RE: Application for Section 14-403 Review #2007-0187
Caribou Street – 197-L-007 & 008
Building Permit #07-1266

Drawing Name:
ROAD IMPROVEMENT SKETCH PLAN

RE: **Application for Sec 14-403 Review
Caribou Street Lot
(Application ID #2007-0187)**

TO: Jean Fraser
FROM: Michael Farmer, Project Engineer
DATE: Dec. 5, 2007
RE: Caribou Street - Proposed Single Family House Lot

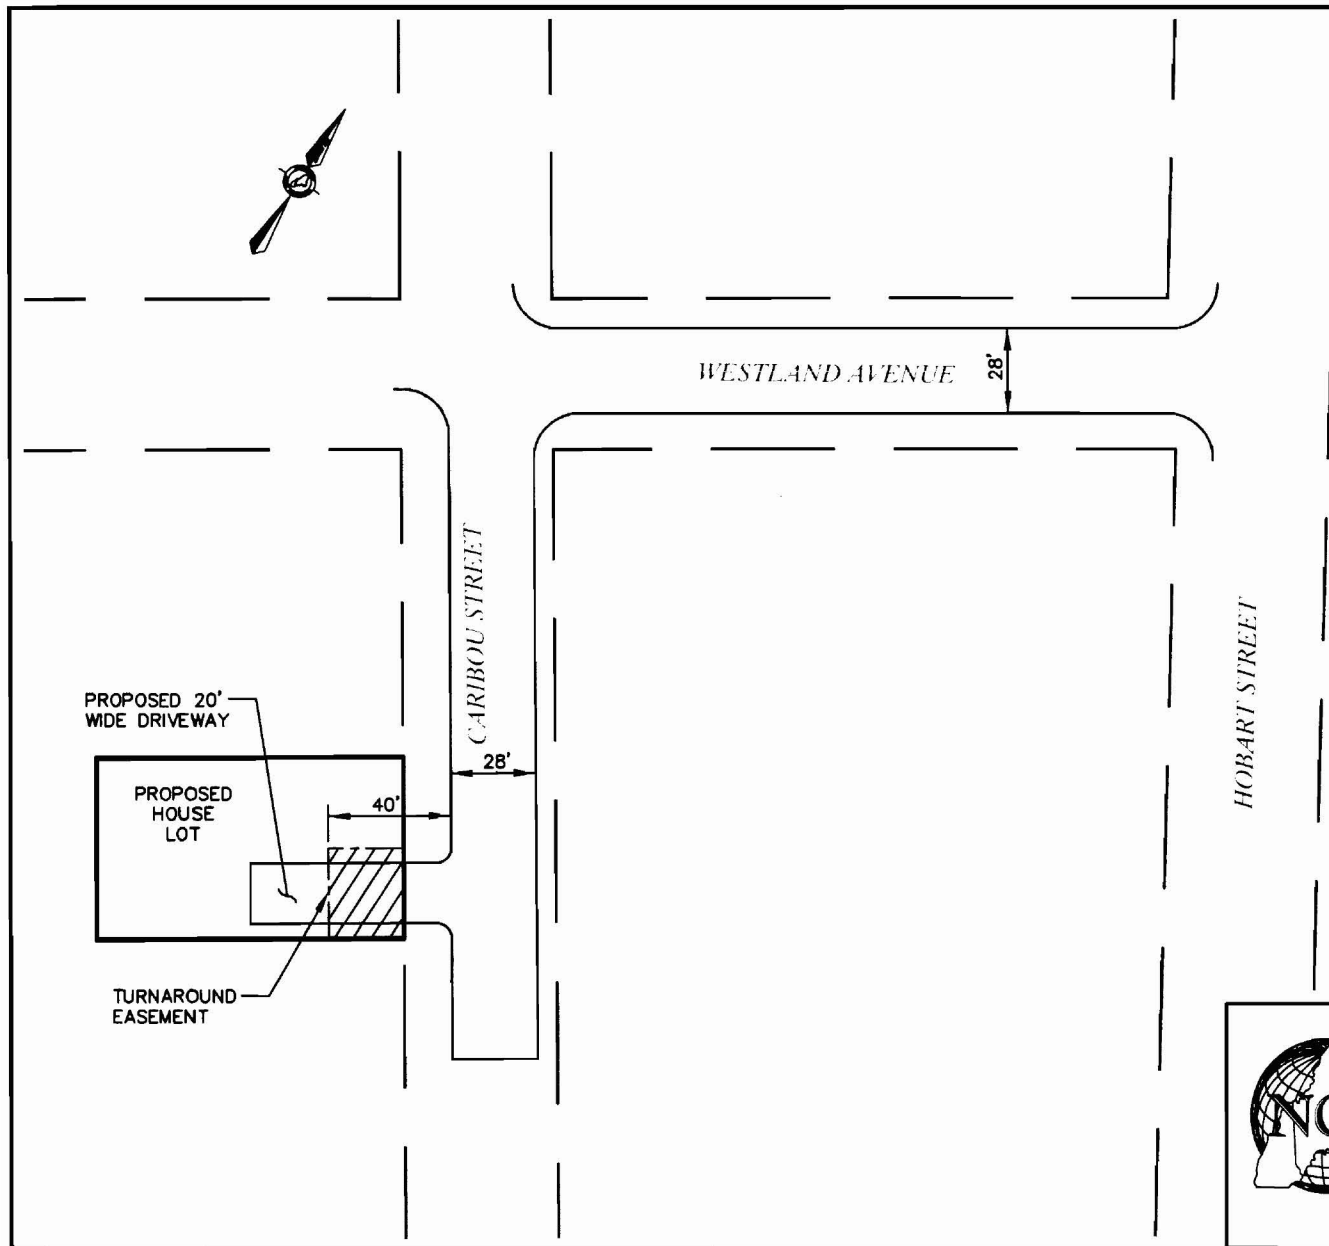
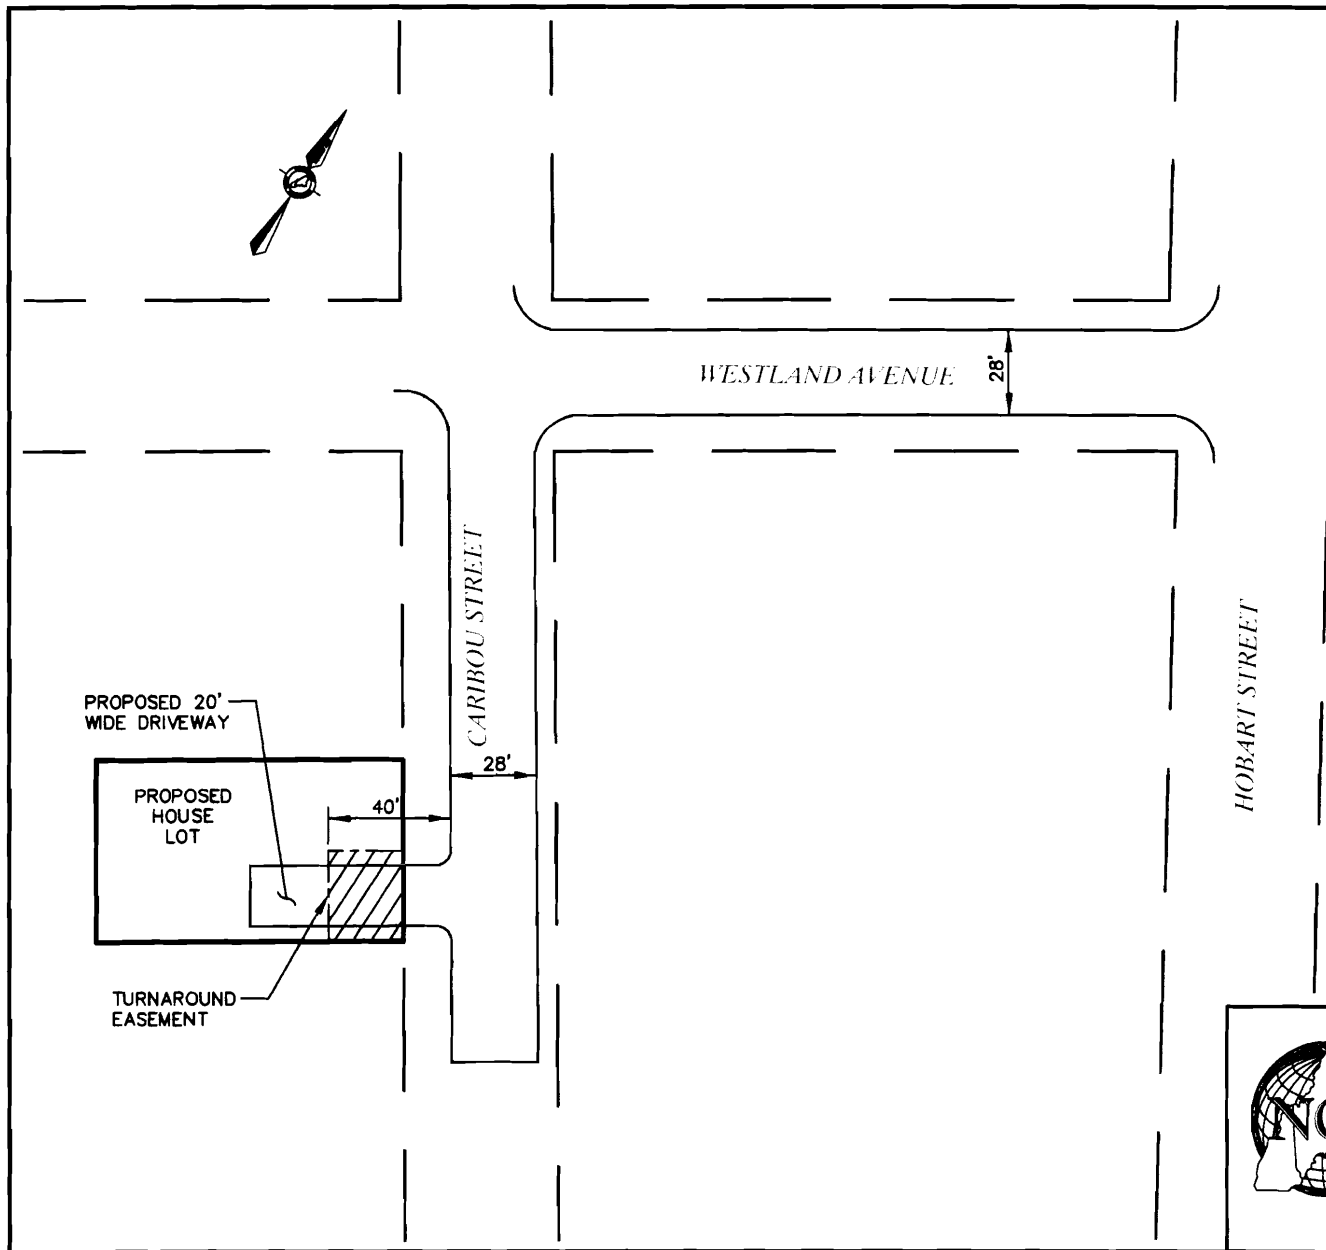
Attached please find sketch of proposed widening improvements to Caribou and Westland to accommodate a house that has been moved onto Caribou for Stuart Carter. Based on his previous discussions with the City we want to make sure that the widening as shown with the turnaround is acceptable to move the project forward. Also based on the information that we have Hobart Street is 24 ft wide, will the widening of Westland and Caribou need to be 28 ft if the street to access it is only 24' wide. Please respond with your comments. Thank you.

Lee,
Mr. Carter must meet all the street requirements that have been outlined in the attached letter to him. Any variances must go to the Zoning Board of Appeals as outlined in this letter.

FIRST FLOOR PLAN

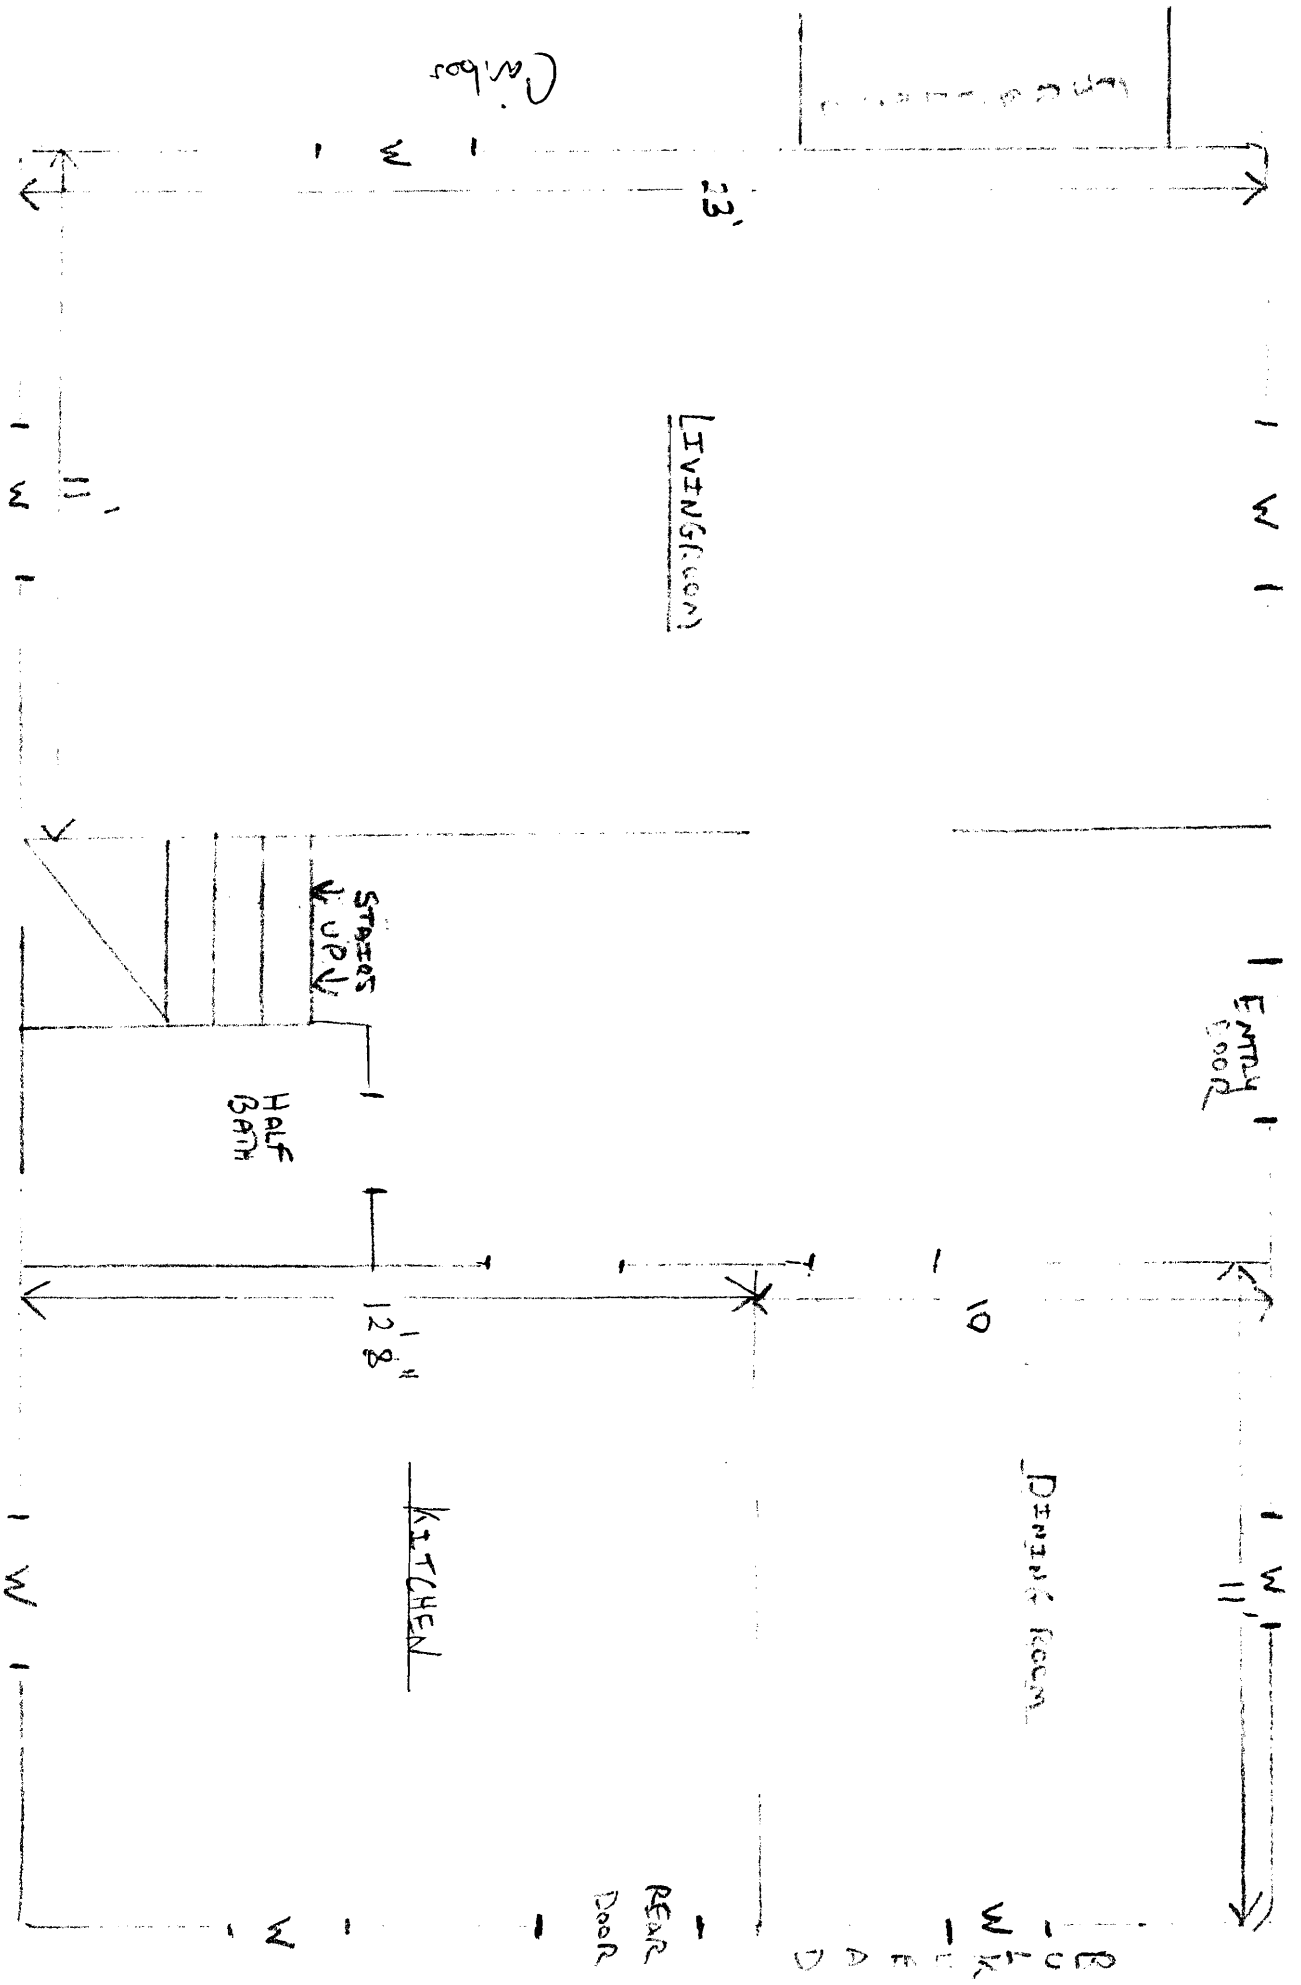
list dimensions?
